TECHNICAL BULLETIN

[Issue No.] T40-0008

[Title] Precautions regarding battery alarm detection of MELSEC-Q series memory card

[Relevant Models] Q2MEM-1MBS, Q2MEM-2MBS

Figure 1 SRAM card back label

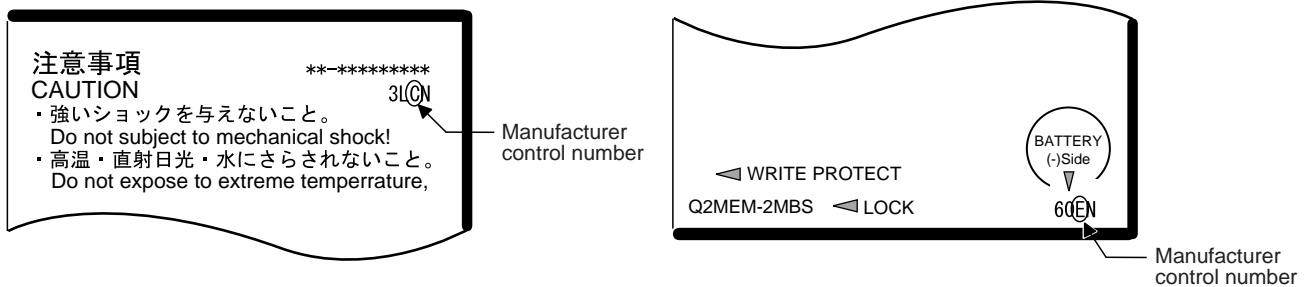
*1: How to check the manufacturer control number

The manufacturer control number can be checked by the number (the 3rd digit from the left) marked on the SRAM card back label.

The manufacturer control number is displayed on the top right or bottom right of the SRAM card back label.
